Project Name:	Coldharbour Farm Road, Emsworth
Document Reference:	187.0018/TN/1
Document Name:	Transport Note
Prepared By:	Mark Smith (May 2026)
Checked By:	Mark Smith (May 2026)
Approved By:	Mark Smith (May 2026)

TECHNICAL RESPONSE TO HCC HIGHWAYS COMMENTS

Road Safety Audit Report

Proposed Continuation of Coldharbour Farm Road Emsworth

DISCLAIMER NOTES:

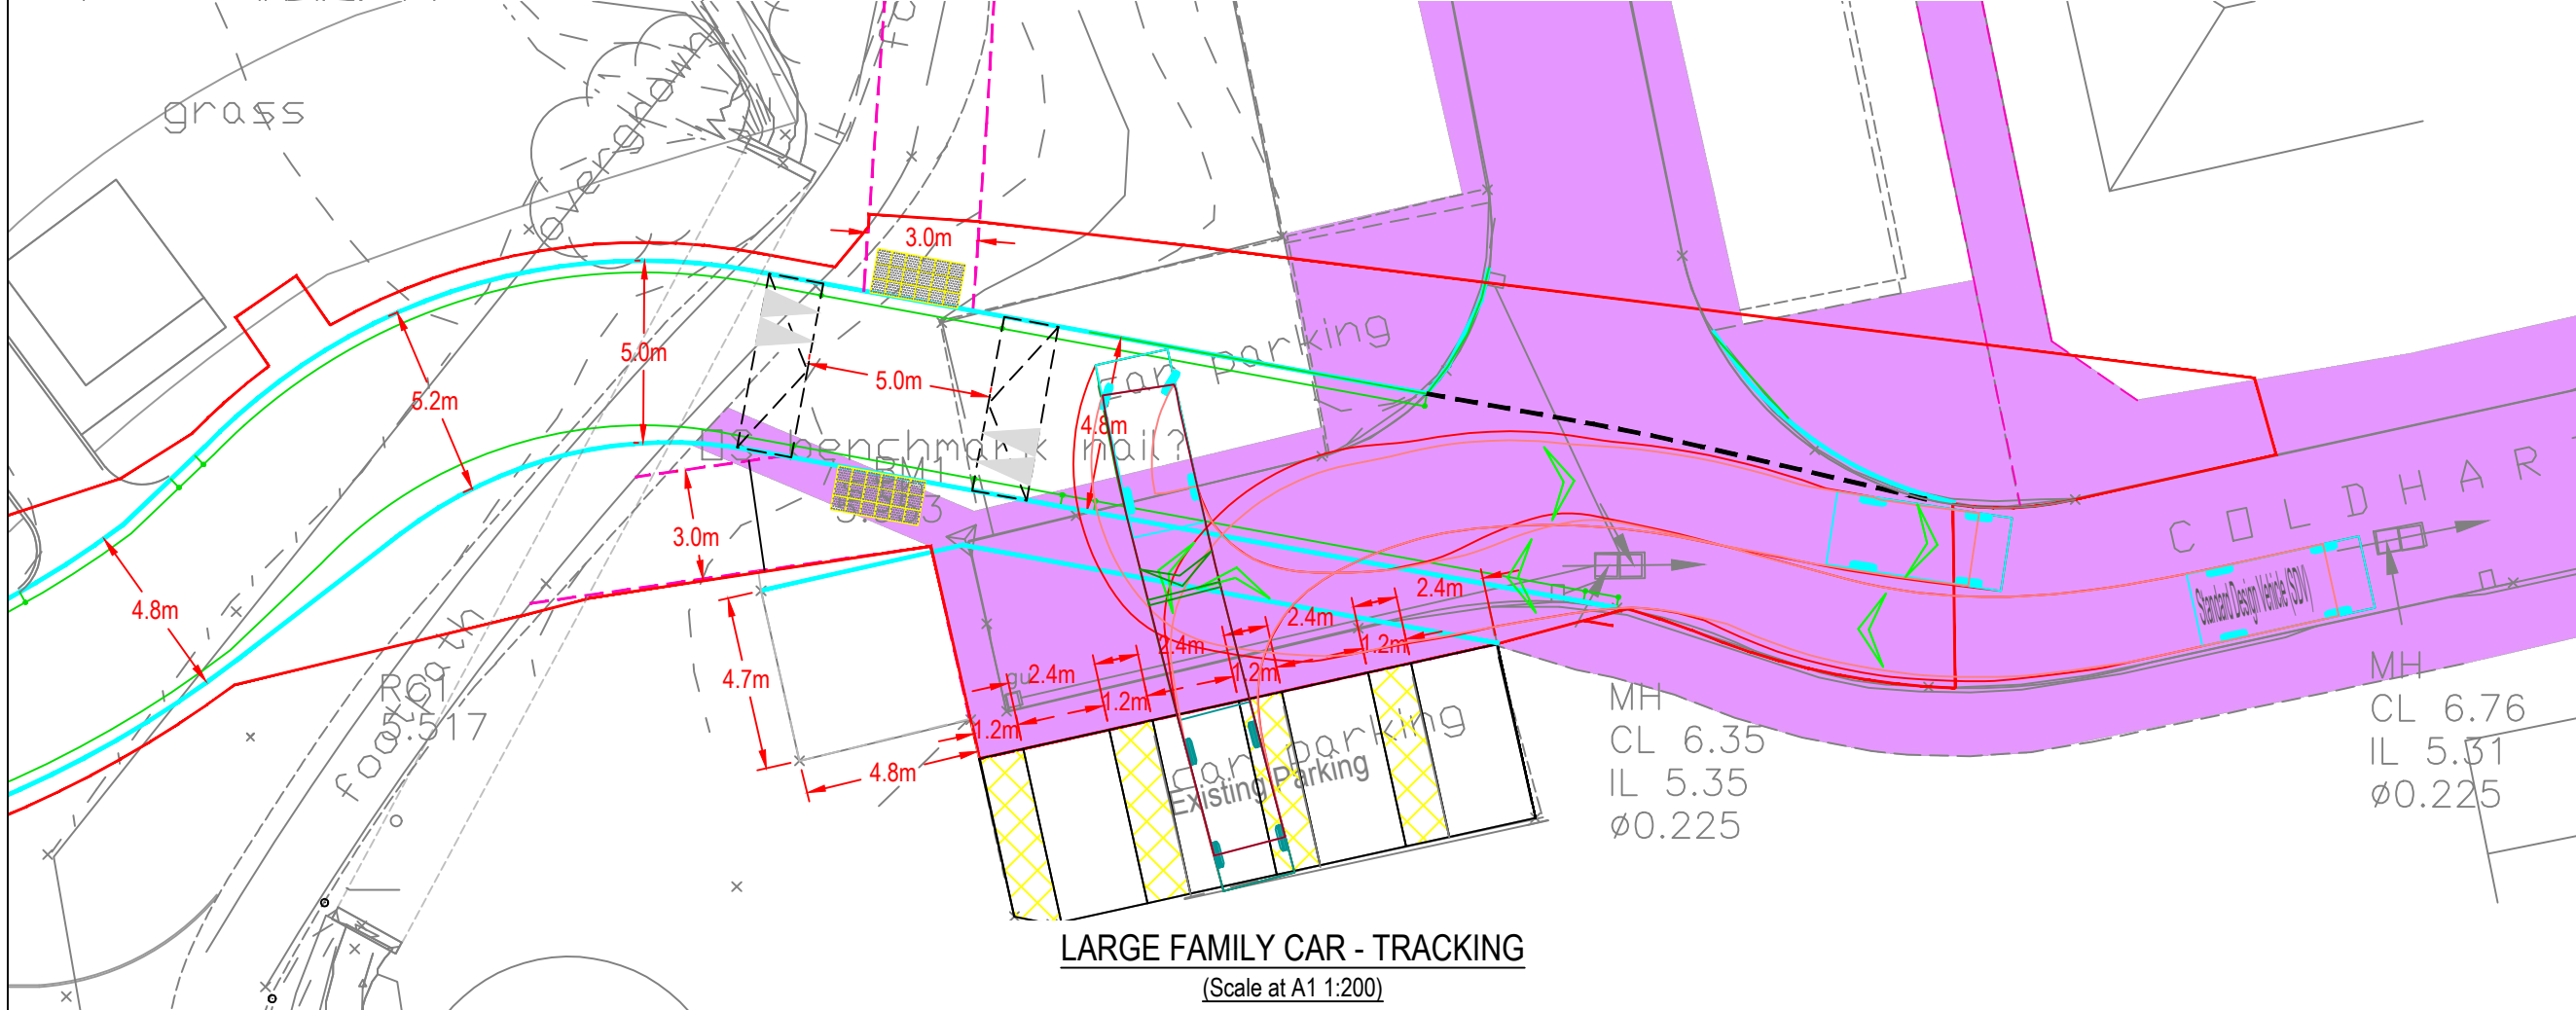
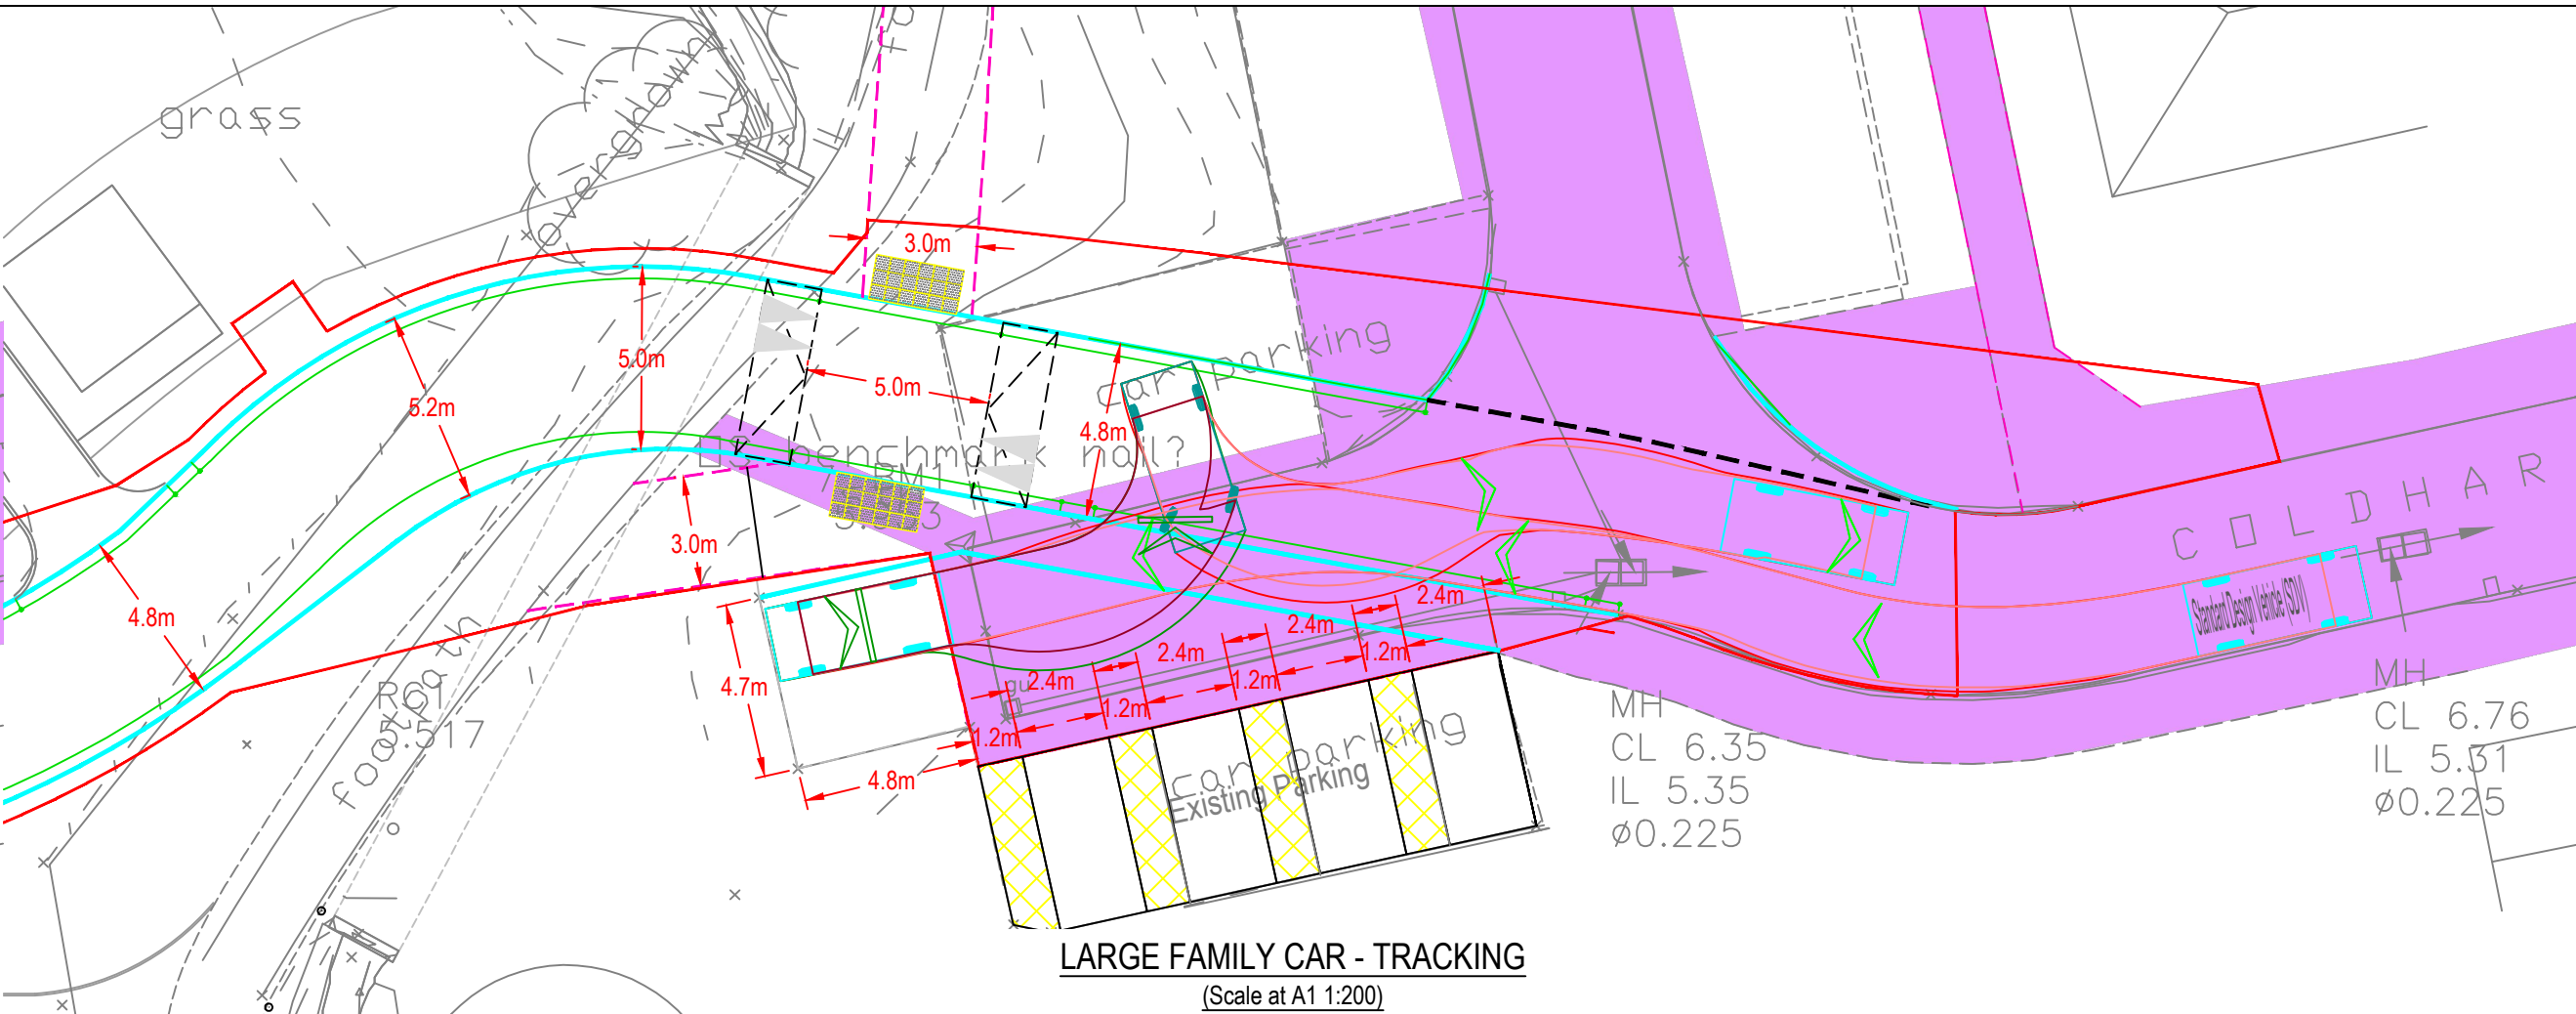
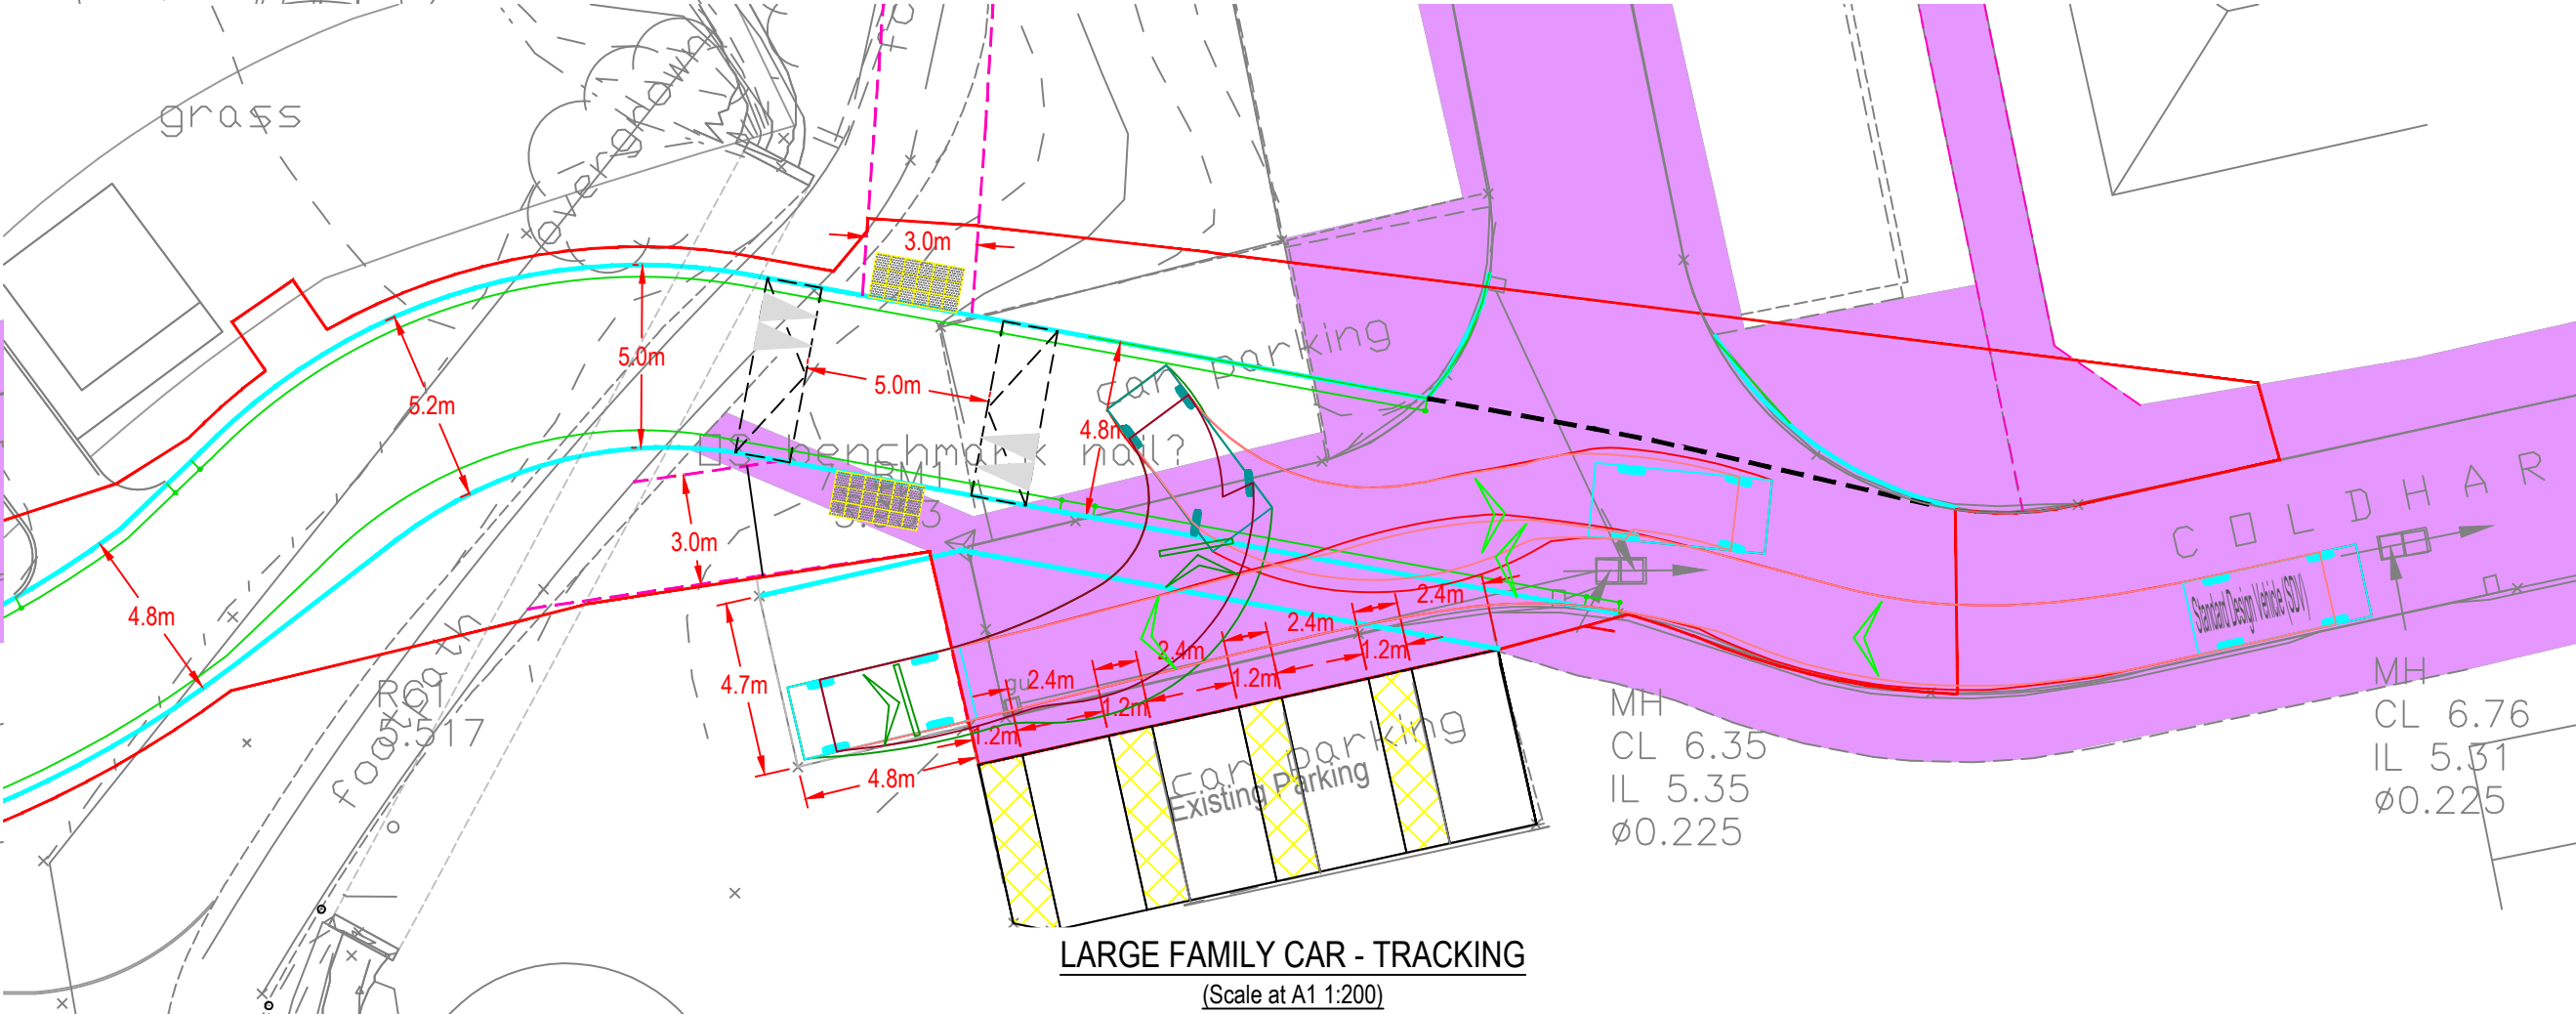
B.1.1 – Alignment may not be adequate for two-way car / LGV movements. It is recommended that the carriageway is adequate for cars and LGVs to pass one another.

We have provided updated tracking Drawing 23339-JUBB-XX-XX-DR-X-001200 REV C4 that shows in the bottom right that cars can pass each other.

DRAWING No: JUBB_XX_XX_DR_C_1203

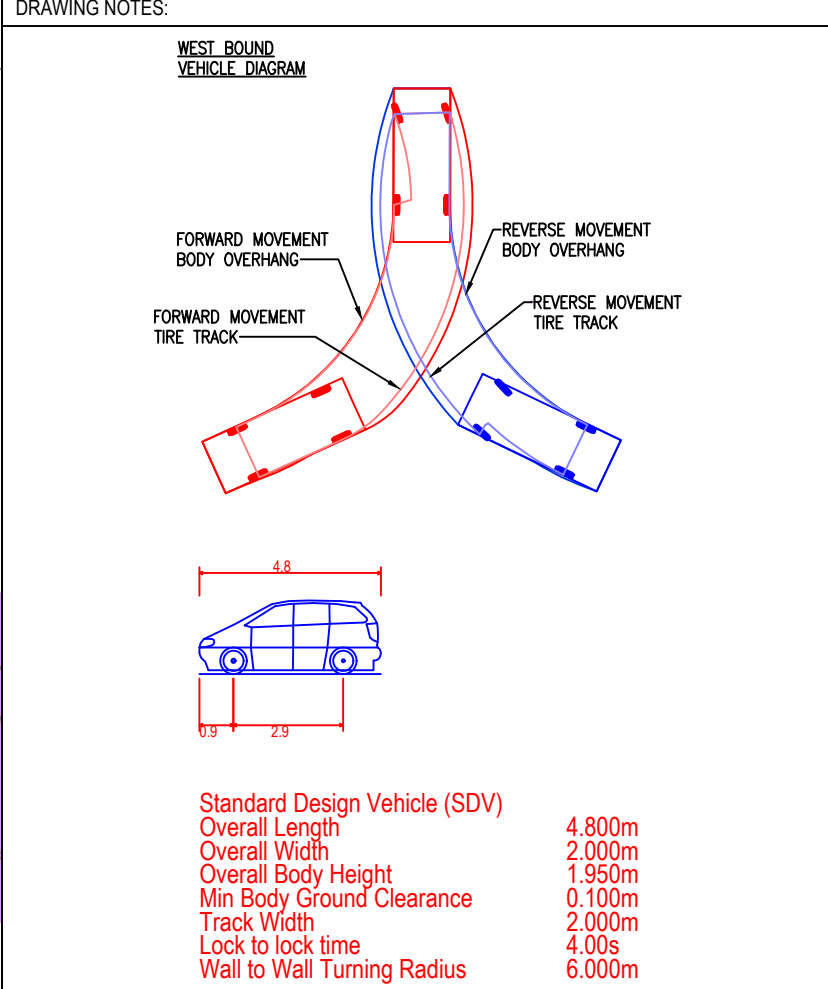
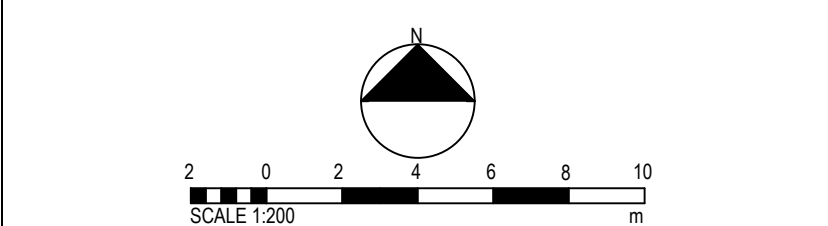
B2.2 Vehicles may not be able to access the existing parking bays. It is recommended that the bays are accessible.

The existing parking bays are proposed to be relined as shown on Drawing 23339-JUBB-XX-XX-DR-X-000100 REV C13 and the tracking is shown on Drawing 23339-JUBB-XX-XX-DR-X-001203 REV C1.
